PLANNING & INFRASTRUCTURE DIRECTORATE

PLANNING PROPOSAL FOR 45 VICTOR STREET AND 410-416 VICTORIA AVENUE CHATSWOOD

ATTACHMENT 2

DETAILED ASSESSMENT

Figure 8 – Recommended setbacks and street frontage heights

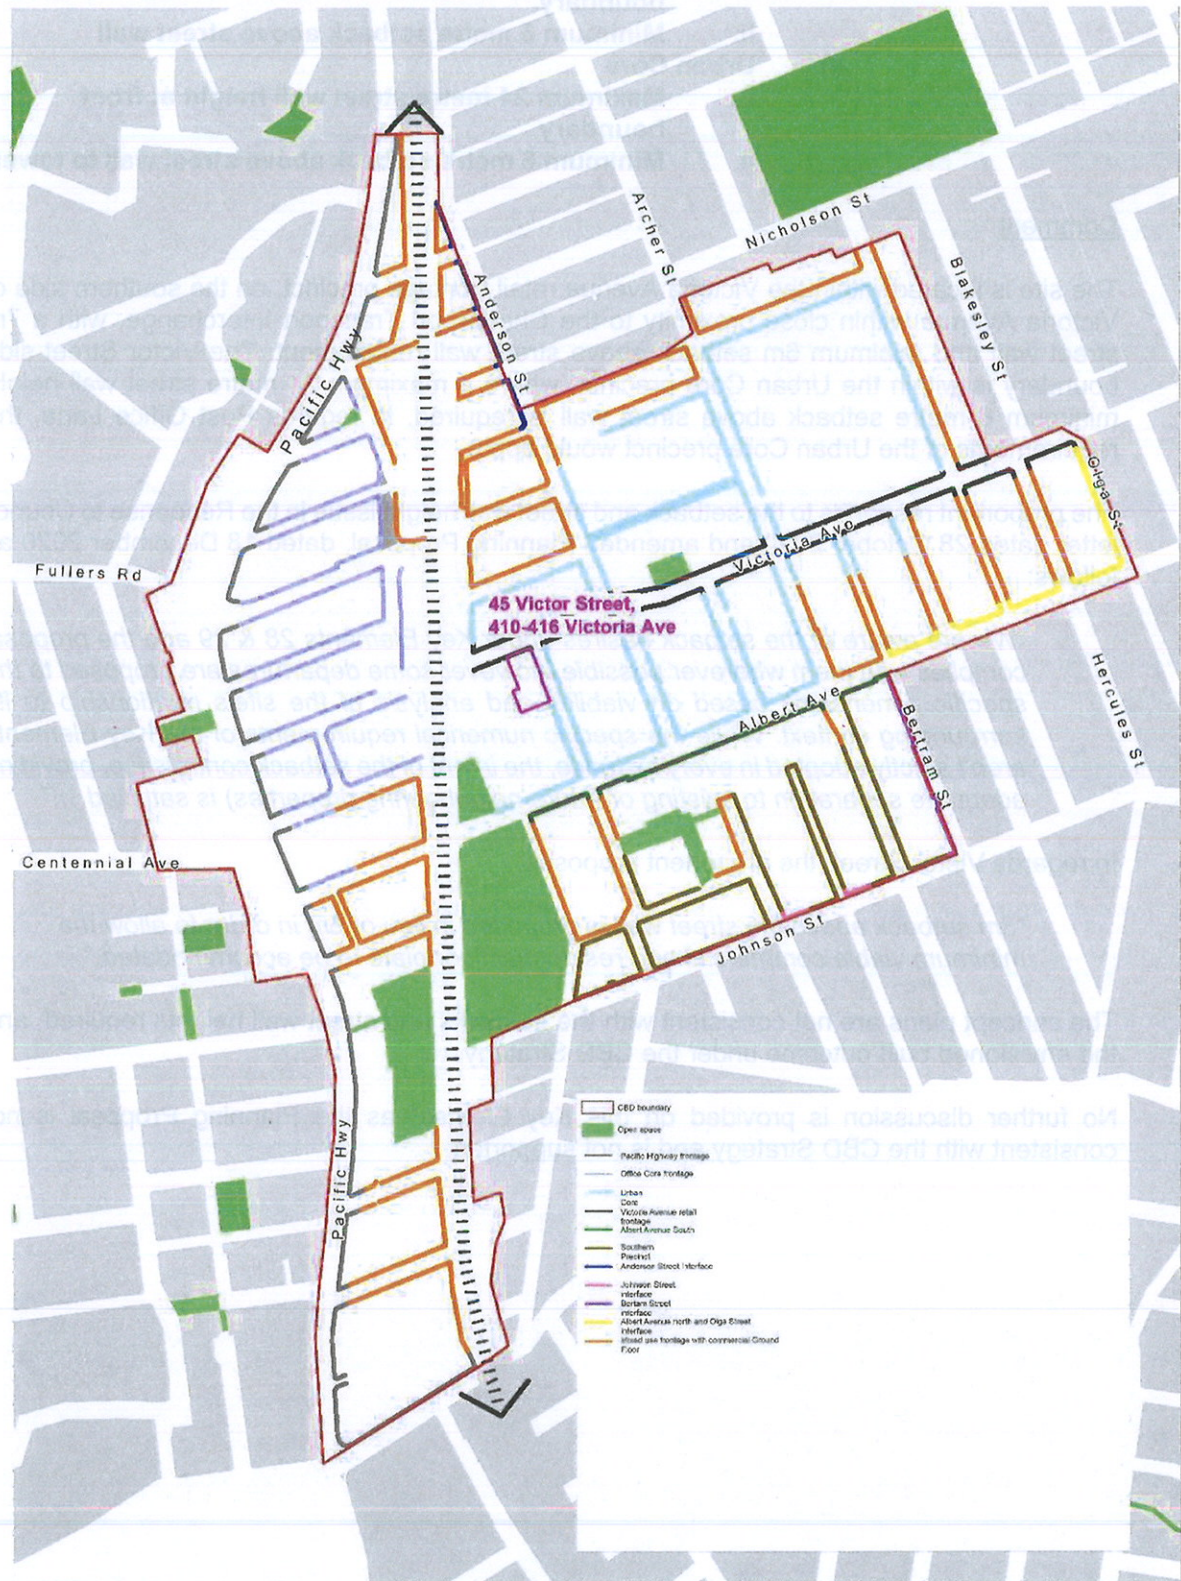
The concept plans are not consistent with the setbacks and street wall heights required, and the envisioned built outcome under the CBD Strategy.

No further discussion is provided on this Key Element as the Planning Proposal is not consistent with the CBD Strategy and is not supported.
